**Client/Project**  
 Champlain Wind, LLC  
 Bowers Mountain Wind Project  
 Carroll Pkt. and Kossuth Twp., Maine

The report entitled *Visual Impact Assessment for the Bowers Wind Project* by LandWorks was submitted as part of Champlain Wind, LLC's permit application (LandWorks 2013).<sup>1</sup> A series of clarifying questions probing the adequacy of the visual impact assessment (VIA) was submitted to DEP on January 8, 2013; additional questions concerning the user surveys was submitted to DEP on January 16. Fieldwork investigating potential scenic impacts to scenic resources of state or national significance (SRSNS) was conducted on May 18-19, 2011 and December 13, 2013. This review reports the findings of additional analyses of the Bowers Wind Project's potential visual impacts, followed by an independent evaluation of the potential visual impacts to state and nationally significant scenic resources, using the Evaluation Criteria presented in the Wind Energy Act. These criteria and how they are interpreted for this review are described Appendix 1. The final section of this report presents the Conclusions of the review.

Review of the Bowers Wind Project Visual Impact Assessmen

**Figure 1.** This selection from a visual absorption capability map shows that peaks and steep slopes have low visual absorption and flat areas have high visual absorption (USDA 1995, p. C-7).

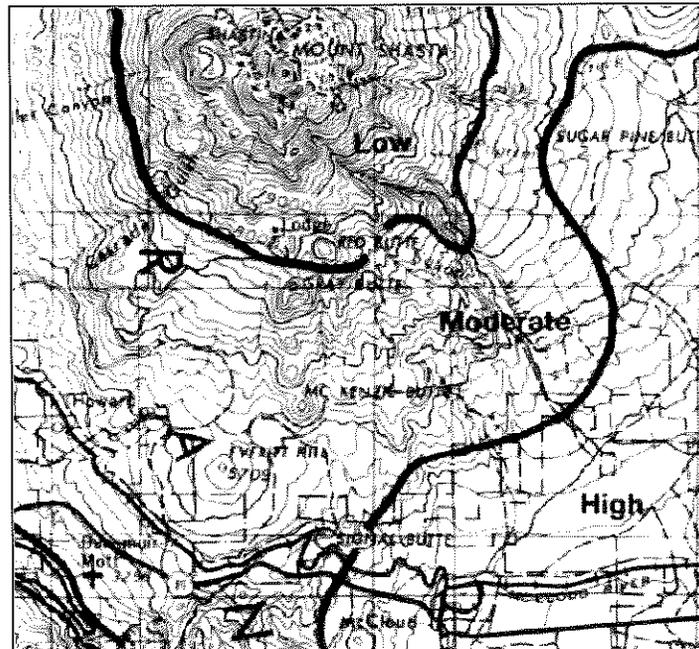
**Visual absorption capability.** The VIA indicates that visual absorption is a component of determining Criterion F Scope and Scale of Visibility from the Scenic Resource (VIA p. 40). Visual absorption capability is a planning concept the US Forest Service developed to manage the potential for visual impacts associated with forest management practices such as clearcutting (USDA 1995, Appendix C). It is implemented through a rigorous mapping analysis (Anderson et al. 1979). Ridges and high slopes are least able to absorb visual change, as indicated by the visual absorption capability map in Figure 1.

A moment of reflection reveals that ridges standing 700 to 800 feet above large open lakes will not absorb views of wind turbines that are 275 feet to their hub and 459 feet to an upraised blade tip, even when the ridges have a forest cover of up to 65 feet. This is why the WEA clearly states that “generating facilities are a highly visible feature in the landscape [and this] is not a solely sufficient basis for determination that an expedited wind energy project has an unreasonable adverse effect on the scenic character and existing uses related to scenic character of a scenic resource of state or national significance.”<sup>4</sup>

**Figure 2.** The effect of higher pixel density for capturing image detail.

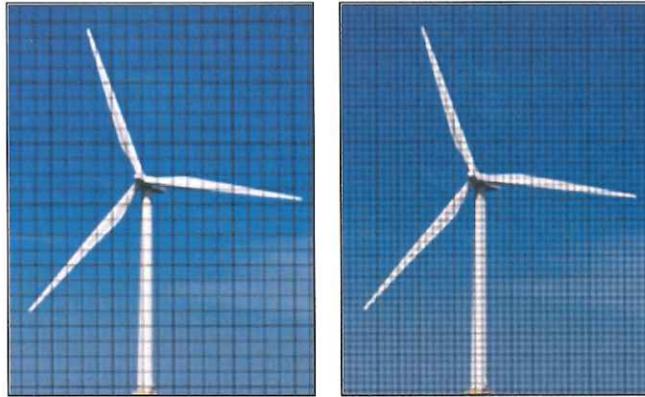
standard to specify a photograph's resolution if it is going to adequately represent visual conditions. Relating this to the dimensions of a wind turbine, the widest part of a blade or the width of a nacelle (both approximately 4 meters) will occlude just over 1 minute of arc.

Conceptually, a digital photograph must have one pixel for each minute of arc. However, the pixels will not always lineup with the actual elements in the landscape (e.g., a blade tip), so the widely used rule of thumb is that the image needs twice the resolution of the target to adequately capture the desired information. This means that there needs to be two pixels for every minute of arc in the lens' view. Figure 2 illustrates the importance of pixel resolution in representing visual information.

The resolution of the original photography is summarized in Table 2. Most of the images have 1.64 pixels per minute, which may be adequate but is slightly below the preferred 2.0 pixels. The Pub Lake photography had very good resolution, though it appears that the resolution may have been down sampled to make it match the other images. Only the Keg Lake image clear has inadequate resolution, which is one of its obvious faults.

### ArcScene Visualization 8: Pleasant Lake West

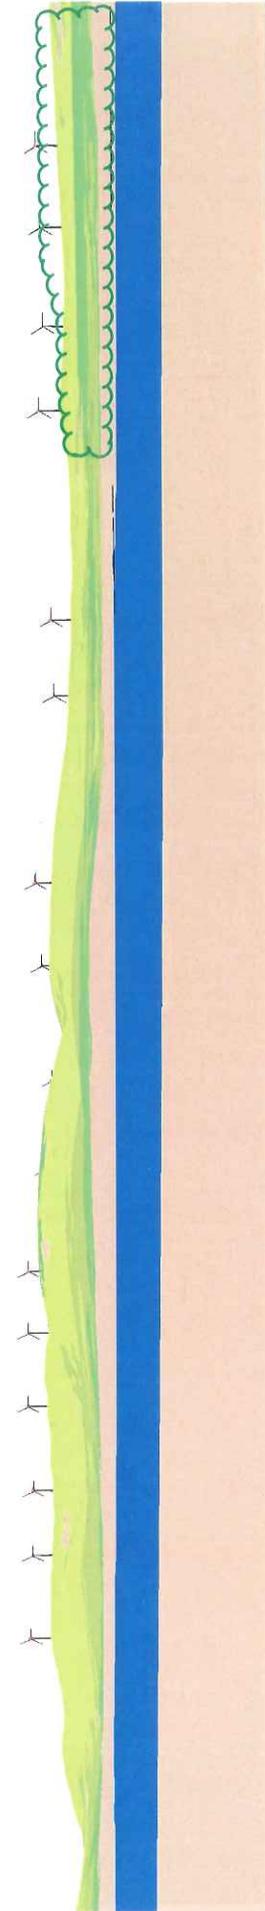
**Scraggly Lake.** The scope and scale of Visualization 8 is very similar to the photosimulation in the VIA's Exhibit 18. While the shoreline vegetation in the photograph is slightly higher than shown on the right side of the visualization, this will not significantly change the visual exposure of the turbines from this viewpoint. This supports the accuracy of the photosimulation.

The purpose of this visualization is to validate the relative accuracy of Exhibit 18: Visual Simulation from Scraggly Lake, Pukakon Twp (LandWorks 2012). It is created using the location and camera information from the photograph metadata and GIS database that were used to prepare the *Visual Impact Assessment for the Bowers Wind Project*. Forest cover is set to 40 feet, and does not include forested wet lands or areas harvested since 1995. The representation of foreground vegetation may not be accurate. The horizontal angle of view is 55 degrees, and the visualization will be in proper perspective when viewed from a distance slightly greater than its width.

Figure 1. FAA warning lights streaking across the water at night.

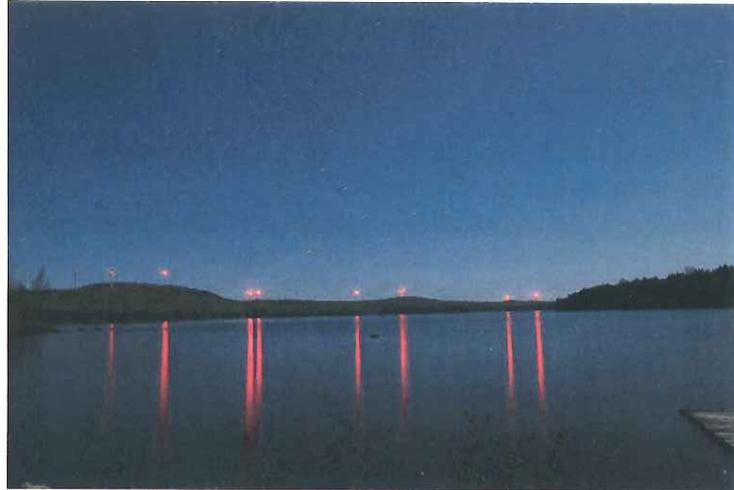
Members of the public in the past have expressed concern about the significant scenic impacts of the FAA aviation warning lights. At the June 2011 hearings for the original Bowers Wind Project, the photo in Figure 1 was circulated. This photo is of the Rollins Wind Project looking from the gazebo park in Lincoln, ME over Mattanawcook Pond. At the time I dismissed it as being either an edited photo or an effect resulting from the long exposure time.

However I went and checked that night and found it was a very good representation of what I saw; the
